TECHNICAL BULLETIN ISSUED: 1 March 2012 DOCUMENT: TB 032

Design Program Upgrade Version 12.3

2) In BASIC DESIGN

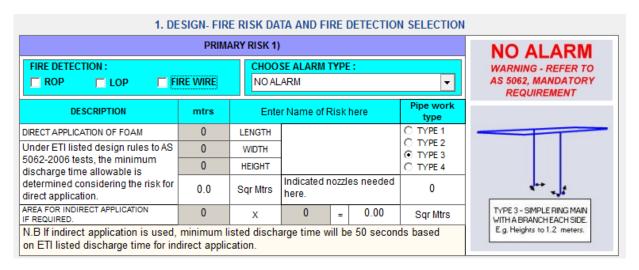
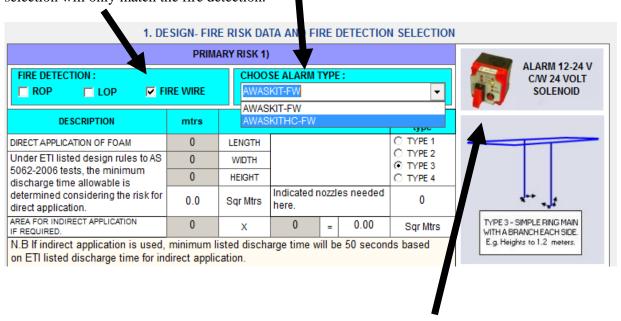
You first must select what fire detection you are using!

When you do that, you must select the alarm that you plan to use. To avoid mistakes the available selection will only match the fire detection.

A picture will appear against the selection made just as a visual confirmation.

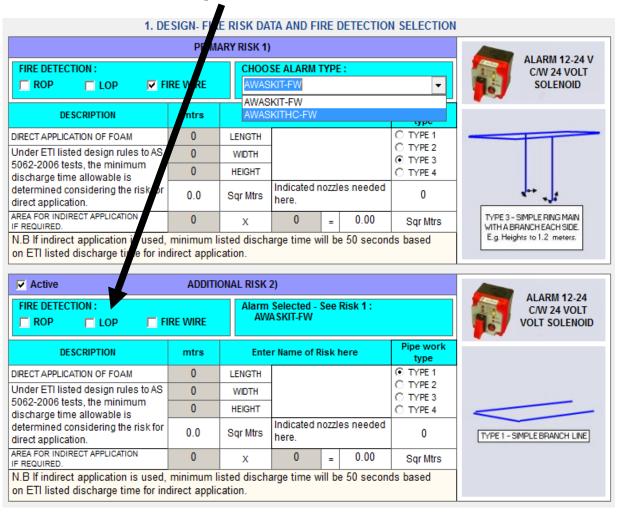
If more fire risk areas are added by clicking the "active" box, you can select fire detection if that is needed for that area, however the alarm being used is already nominated from Risk 1, so alarm cannot be changed here. It is however reconfirmed with the same picture.

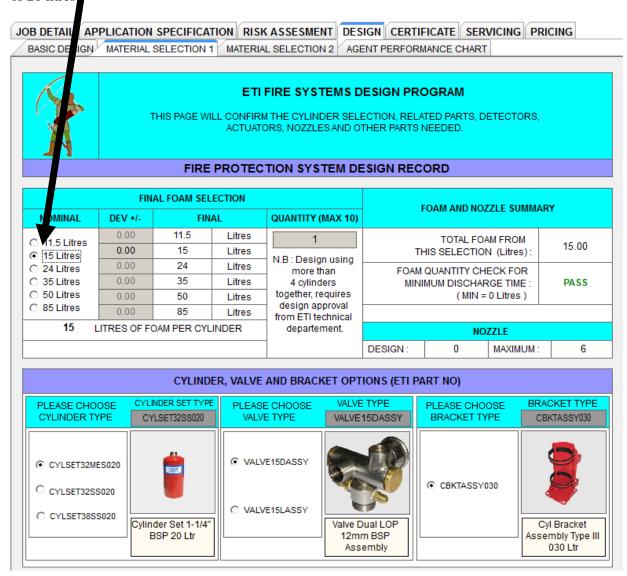
At the bottom of BASIC DESIGN is the TOTAL RISK SUMMARY where the important calculations are made for agent quantity, nozzle quantity and predicted discharge time. Here is where the alarm shutdown delay setting must now be nominated.

A slight change to minimum discharge time rule will now apply. The time estimated to achieve engine shutdown will be added to the absolute design minimum. Above, the new Super Agent has a minimum discharge time of 25 seconds, however the selected 6 seconds for engine shutdown has been added to this. This is intended to keep designs on the conservative side of absolute minimums, allowing for the disruption to fire fighting effect that may be caused while the engine is still running.

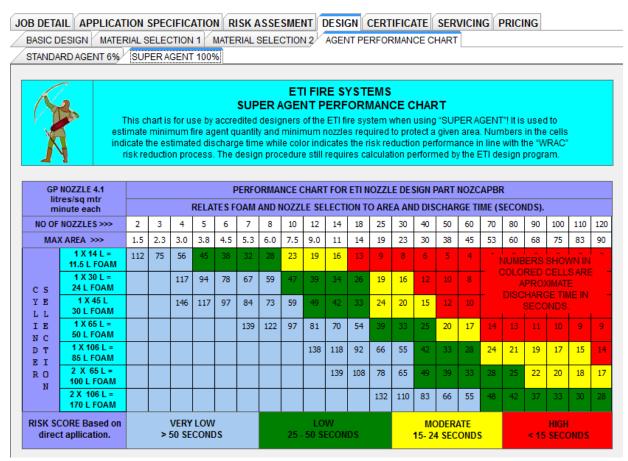
4) In the AGENT PERFORMANCE CHART area, there is now a second tab for SUPER AGENT. This is the same concept you have been trained on for the standard 6% agent which is still there on the adjacent tab. The new Super Agent chart reflects the much lower minimum discharge times listed for this product, and presents it in the same risk profile as our standard Workplace Risk Assessment and Control WRAC. Of course the design program already handles the design relationship between Area, No of Nozzles and the amount of Agent used in a design. These charts are intended to provide assistance in presentations and training or where an estimate needs to be made preliminarily before using the design program.
